PZ&B Staff Combination Memorandum: Landmarks Preservation Commission and Town Council

SUBJECT: ZON-23-117 (COA-23-043) 235 BANYAN RD (COMBO)

MEETING: MAY 22, 2024, LPC
JUNE 12, 2024, TC

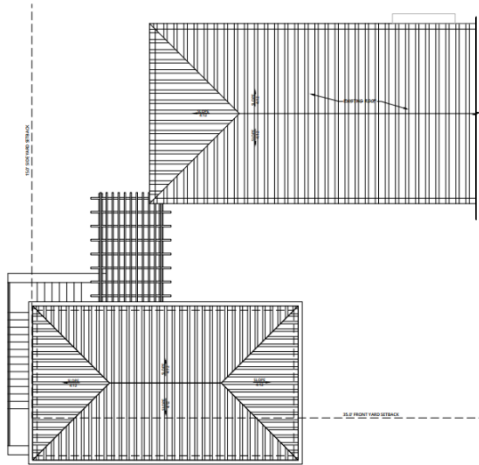
The application as proposed requires three (3) variances for construction. As the diagram below illustrates, **Variances 1 and 3** seek a reduced front setback of 30'-3¾" in lieu of the required 35'-0" per Section 134-843(a)(5) and a reduced side yard setback of 12'-0" in lieu of the required 15'-0" per Section 134-843(a)(8).

Code Section	Required	Proposed	Variance
Variance 1: Sec. 134-843(a)(5)	35'-0" Front Setback	30'-3¾" Front Setback	4'-8¼"
Variance 3: Sec. 134-843(a)(8)	15'-0" Side Yard Setback	12'-0" Side Yard Setback	3'-0"

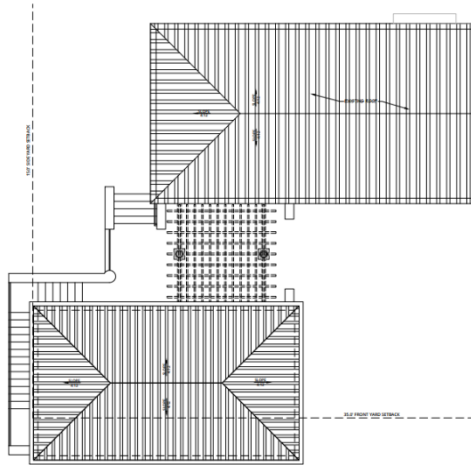
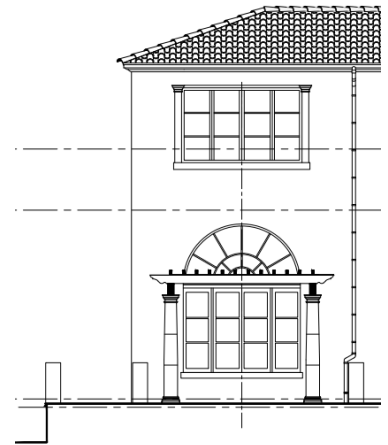
The revised design alters the location of the trellis and columns on the north side of the addition:

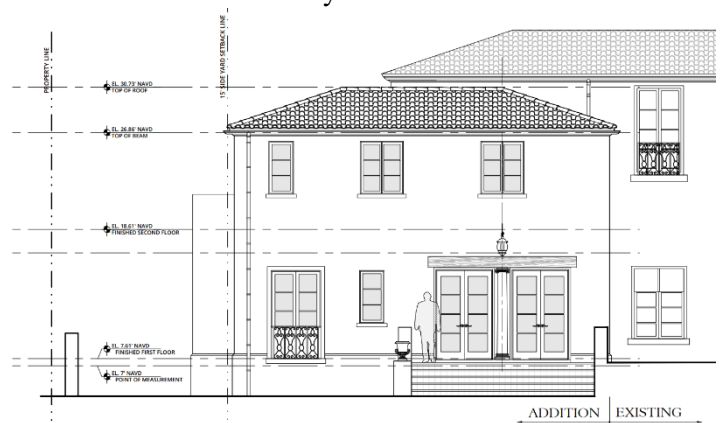
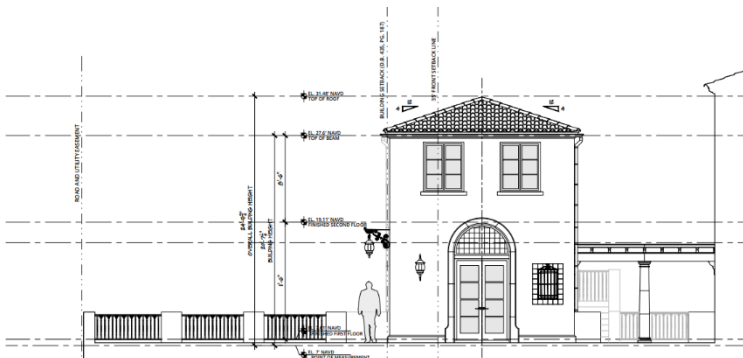
The building height and overall building height was reduced by 9". On the south elevation, the size and scale of the windows and doors was reduced. A pair of casement windows is proposed on the second floor in lieu of the previously proposed French doors and Juliet balcony.

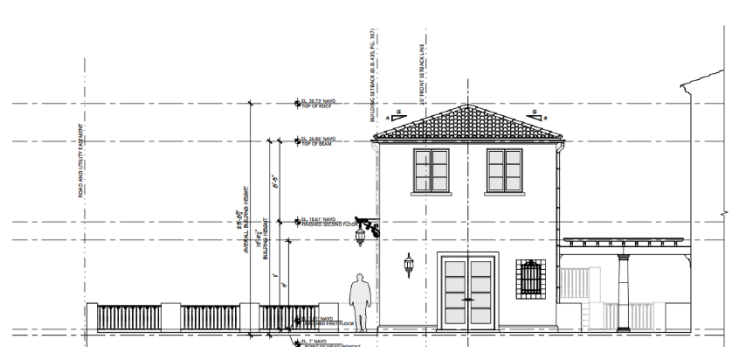
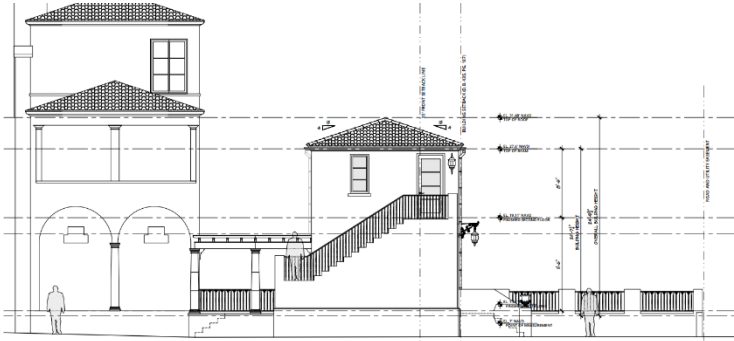
On the east elevation, the size and scale of the windows was reduced. In addition, the arched stone trim and decorative tile were removed and replaced with a stucco band.

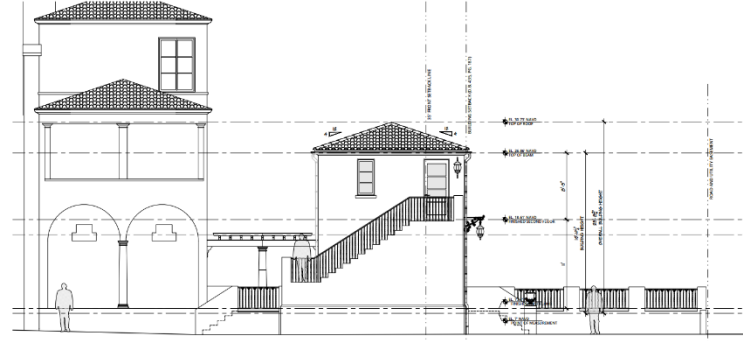
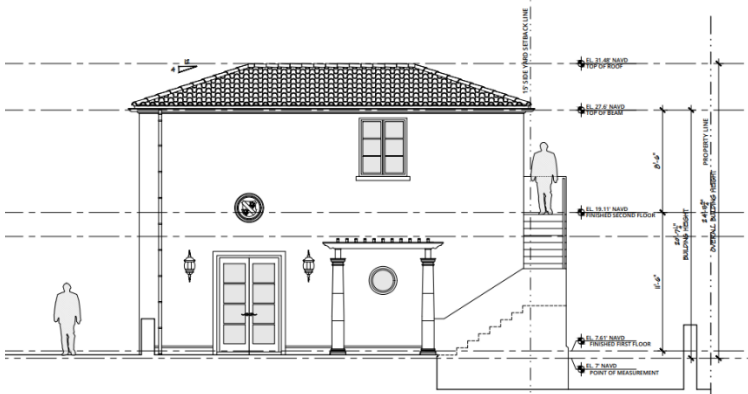
On the west elevation, the size and scale of the window was reduced. Also, the door height was reduced.

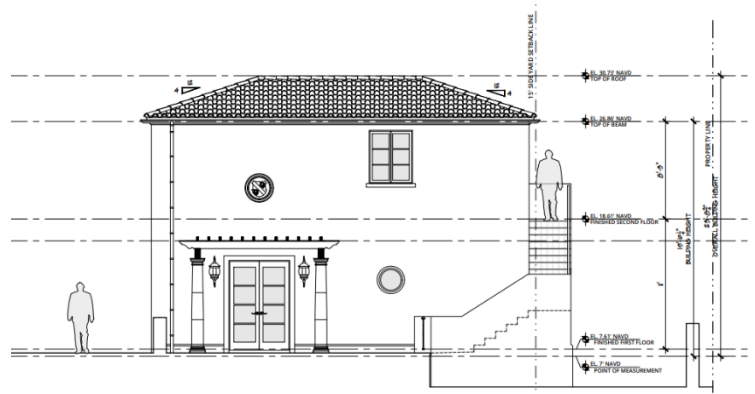
On the north elevation, the size and scale of the window was reduced. In addition, the proposed trellis was relocated to align with an existing window on the residence and a new door on the addition.
